3. (ONCE AMENDED) The power supply device according to claim 2 further comprising a rush current prevention unit being provided in a downstream side of the main power supply unit, the control power supply unit, and an upstream side of the control unit to prevent a rush current from flowing in.

### REMARKS

FIG.5

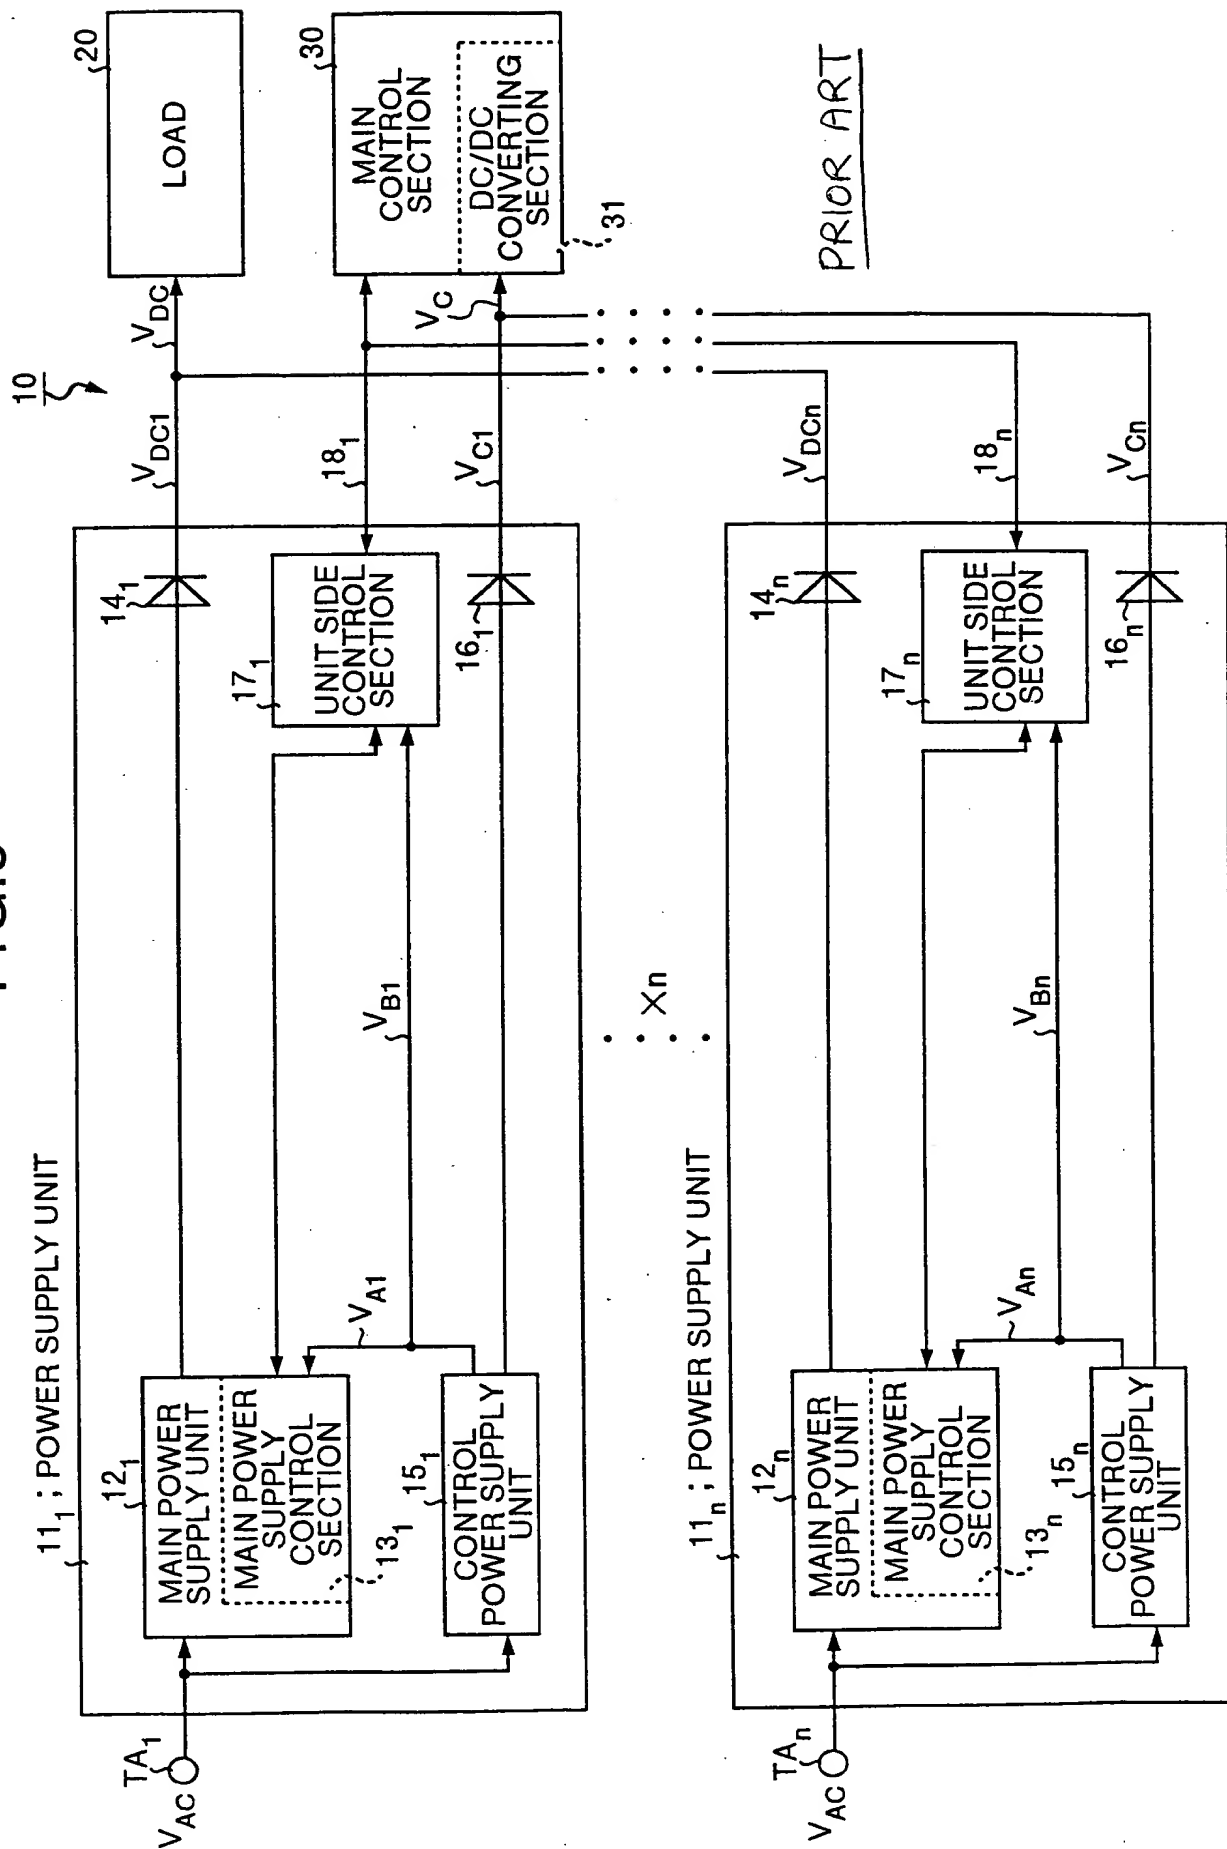
In the Office Action, at page 2, the drawings were objected to as set forth in MPEP § 608.02(g). The Examiner stated that FIGs. 5 and 6 should be designated by a legend such as -- Prior Art-- because only that which is old is illustrated. In the Letter to the Examiner Requesting Approval of the Changes to the Drawings being filed herewith, a copy of which is attached hereto, Applicant has made the requested designation for FIGs. 5 and 6 as shown in red. Also, for the Examiner's convenience, unmarked corrected FIGs. 5 and 6 are enclosed. Accordingly, it is respectfully requested that this objection be withdrawn.
